<b>DOCKETED</b>	
<b>Docket Number:</b>	23-OPT-02
<b>Project Title:</b>	Darden Clean Energy Project
<b>TN #:</b>	258490
<b>Document Title:</b>	CEC Data Request Response Set 5
<b>Description:</b>	Provides the Applicant's fifth response set to data requests received from the CEC. Responses address data requests related to Biological Resources, Hazardous Materials Handling, Project Description, Water Resources, and Worker Safety. The document includes the following appendices to support responses: Appendix A REV 1 DR HAZ-1 Supplemental Soil and Water Sample Results, Appendix B REV 1 DR WS-1 Updated Fire Alarm Site Plan, Appendix C REV 1 DR WS-2 Fire Protection Engineering and UL 9540A Interpretation Report, Appendix D REV 1 DR WS-2 Tesla Megapack 2/XL Hazard Mitigation Analysis, and Appendix E REV 1 DR WS-3 Lithium-ion Battery Electrolyte Safety Data Sheets.
<b>Filer:</b>	Evelyn Langsdale
<b>Organization:</b>	Rincon Consultants

# Darden Clean Energy Project (23-OPT-02)

## CEC Data Request Response Set #5

**Figure 6 Aerial Simulation of Post-Construction Project Components**

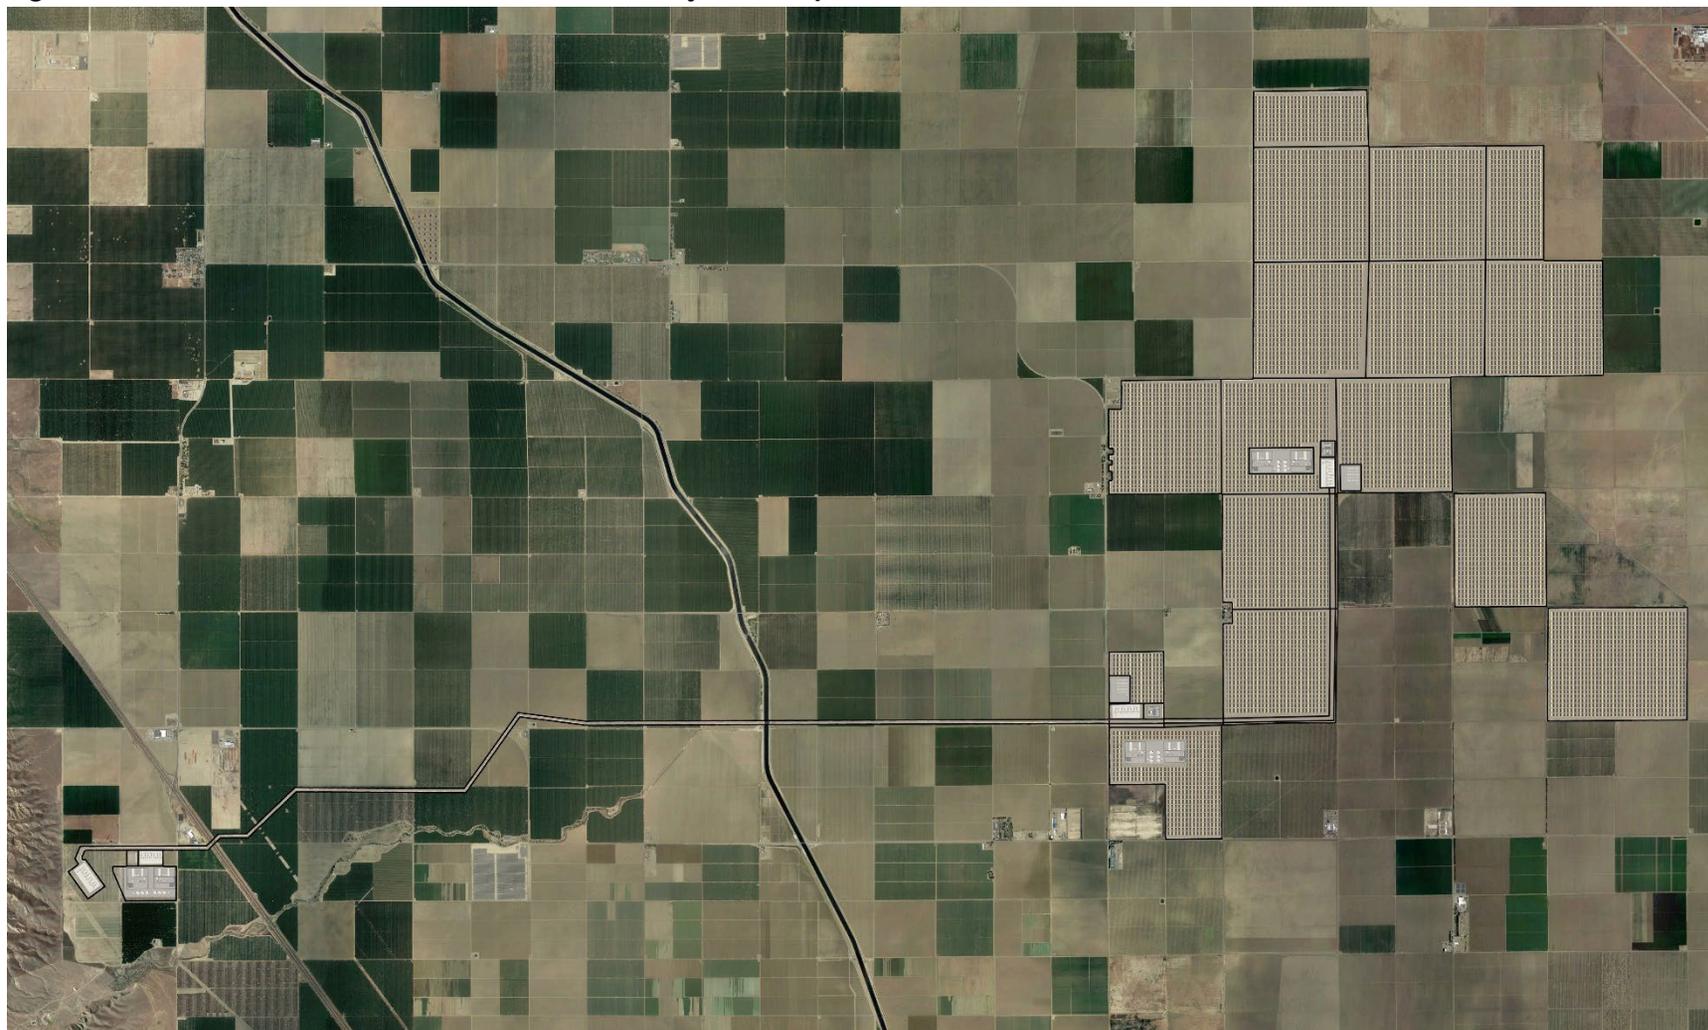
**REV 1 DR PD-3:** In response to DR PD-16, Figure 5 in *CEC Data Request Response Set 2* appears to show photo simulations of the various project components, except for the photovoltaic (PV) panels. Please update this figure to include a photo simulation of the PV panels. Please also provide a clearer photo simulation of the other project components.

**Response:** An updated aerial photo simulation showing the solar PV panels and other project components for each Project alternative is provided in Figure 6 below. This image file (.jpeg) is also being provided as a standalone file with this submittal to ensure a high-quality version is available for review.

SHEET TITLE:  
FIRE ALARM SITE PLAN

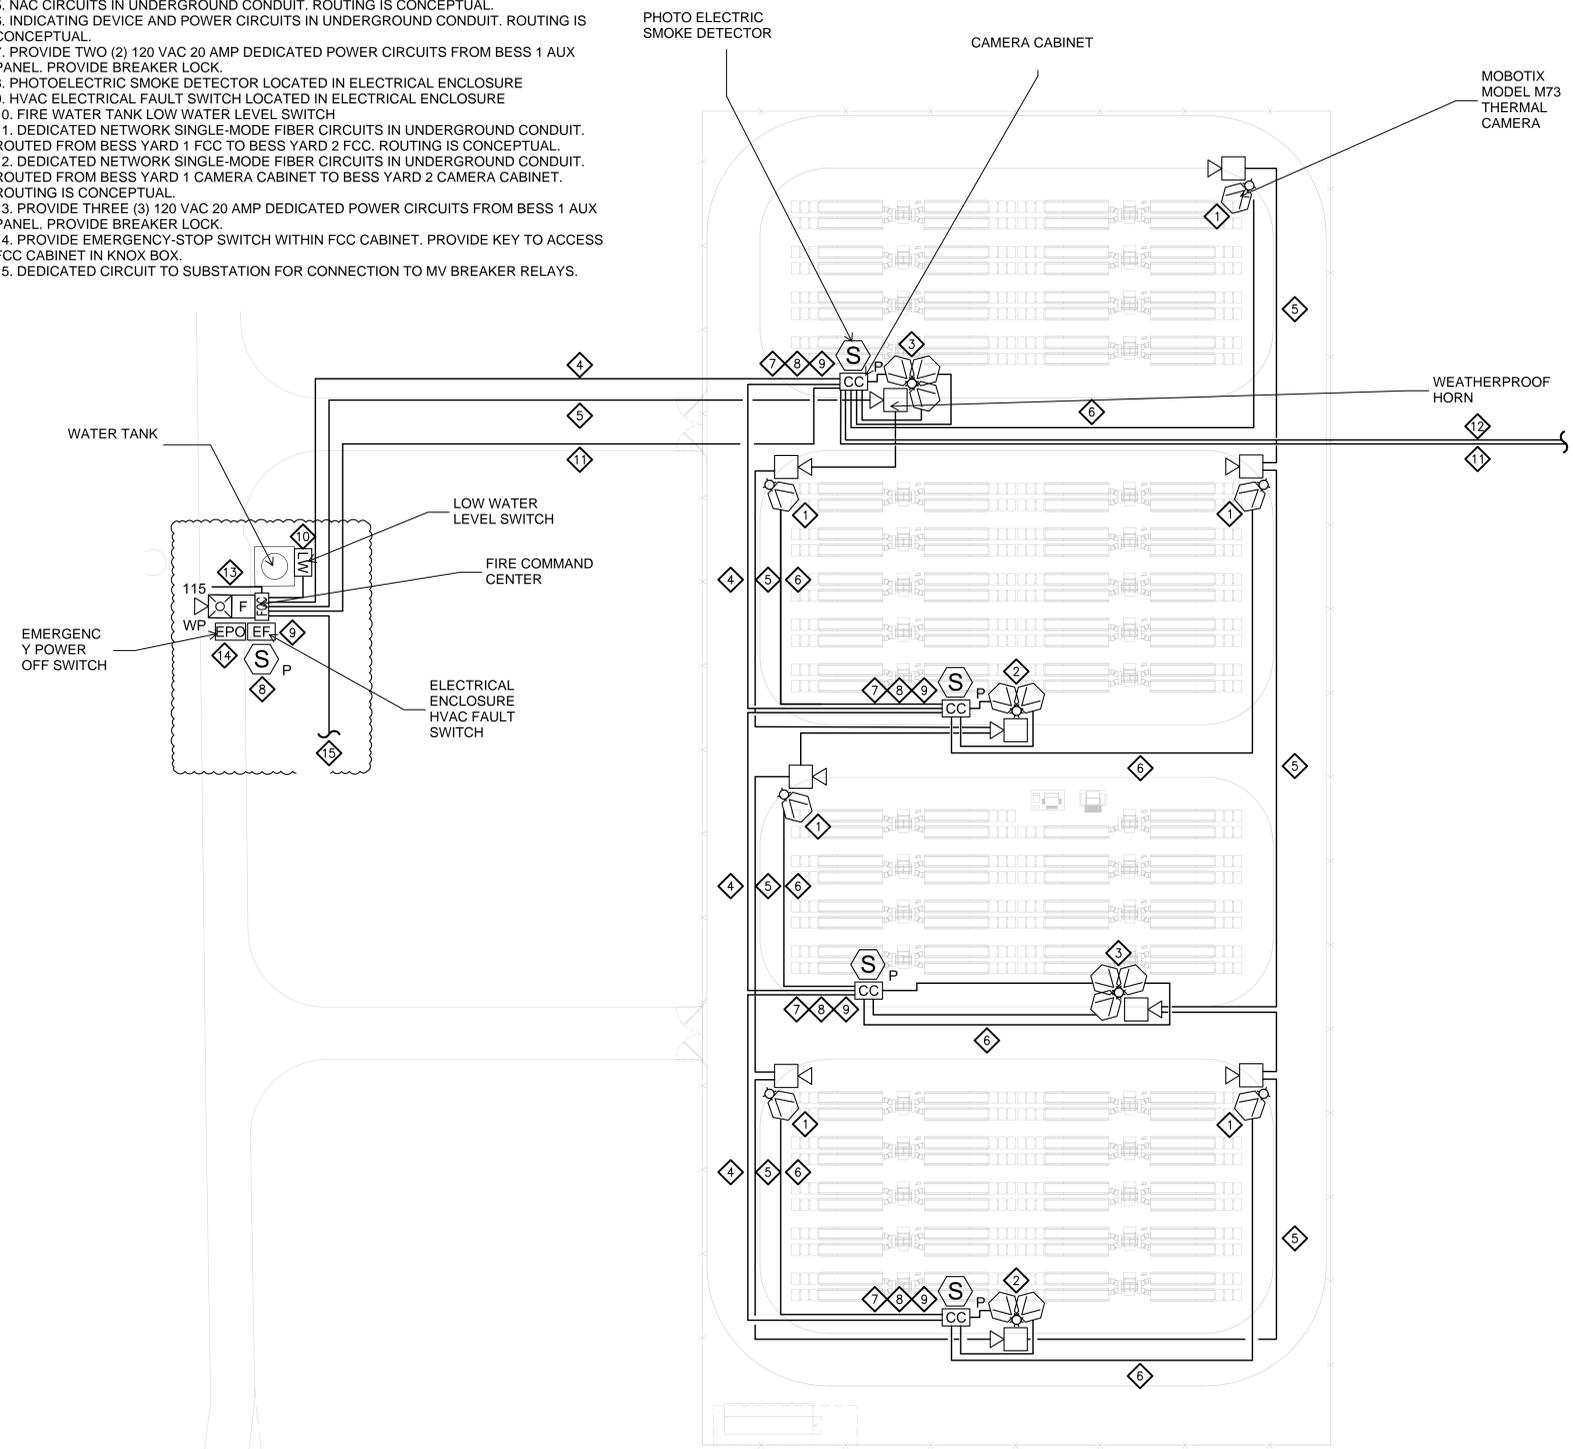
**REV 1 DR WS-1:** Figure 1 showing a typical BESS fire protection layout was submitted in response to staff's DR WS-3 on page 29 of *CEC Staff Data Request Response Set 1*; however, the figure was not clear enough for readability. Please submit a revised Figure 1 that is legible and easier to see how the BESS would be designed and sited. Please ensure that all components of the proposed BESS fire detection and suppression system are clearly marked on the figure including alarms, detectors, any water tanks, water mains and pipes, hydrants, fire water monitors (cannons), sprinkler or deluge systems, post-indicator valves, etc.

**Response:** An updated, full size Fire Alarm Site Plan figure was submitted through the CEC's Kiteworks platform on June 17, 2024 and is also attached to this data request submittal as Appendix B.
